DEPARTMENT OF NUCLEAR ENGINEERING AND ENGINEERING PHYSICS  
REACTOR FACILITY

September 27, 1982

RE: Minor Modifications in Emergency Core Spray System Piping

FIGURE 3

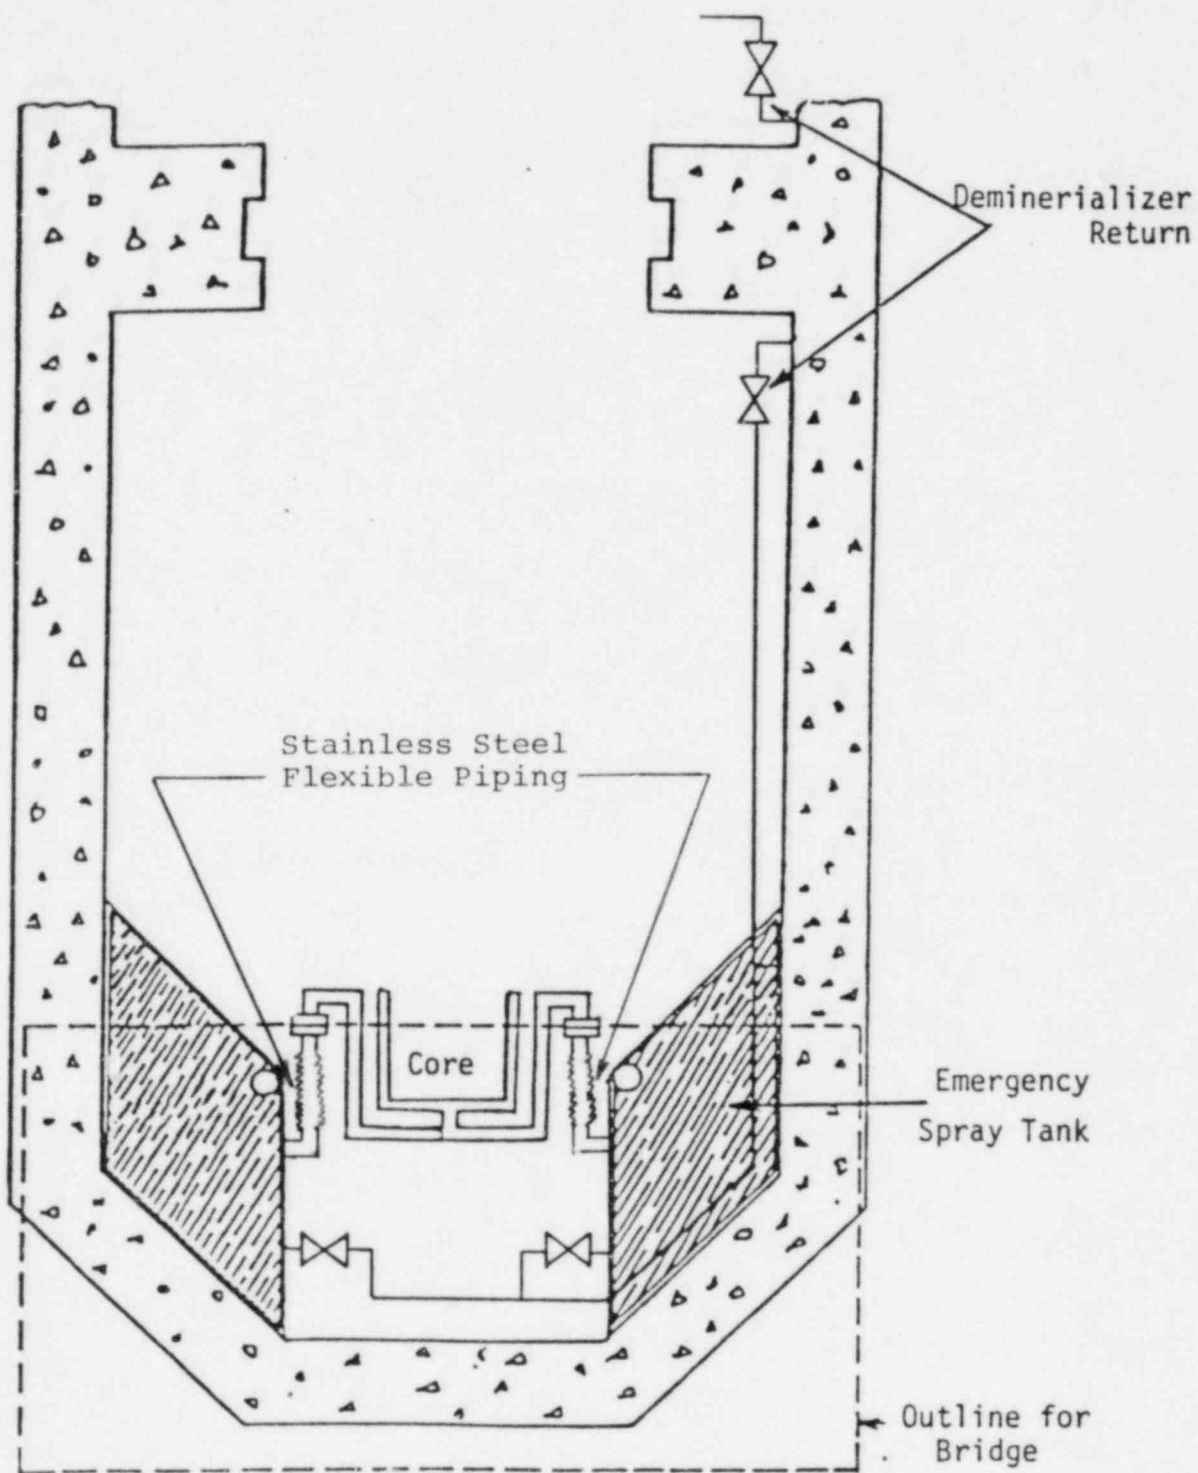
The reactor staff concluded that a section of flexible stainless steel piping should be placed on the tank side of the remote coupling to provide the necessary movement for coupling alignment. The University Reactor Safety Committee met on September 7, 1982, to review this proposed change. It was concluded that the crack had been caused by the manipulation of the piping to achieve alignment and that the staff's proposed insertion of the flexible pipe would rectify the problem. It was decided that the proposed change should be made in both spray tank pipings to avoid future alignment problems.

On September 16, 1982, the repair and updating of the ECSS tank piping was completed. Figure 3 illustrates the position of the section of flexible pipe. The reactor bridge was moved into the high power position. The remote couplings mated and were locked together with no alignment problems whatsoever. An air pressure test of both tanks indicated that the couplings and connecting piping had no leaks. The ECSS was tested for coolant flow rate to ensure that the piping changes had not caused any deviation in flow rate which would violate the Technical Specifications. The flow rate from the south east tank was unchanged. The initial flow rate from the south west tank system was 3.1% higher than the previous test with the original piping (from 13.0 gpm to 13.4 gpm). Test data over a four year period (March 1979 to January 1982) indicated that the south east tank system had a  $\pm 3\%$  deviation in initial flow rate while the south west had a deviation of 1.1% over the same period. Thus, the staff concluded that the flow rate from the south west tank system will have no effect on the ability for the ECSS to meet the Technical Specification requirements.
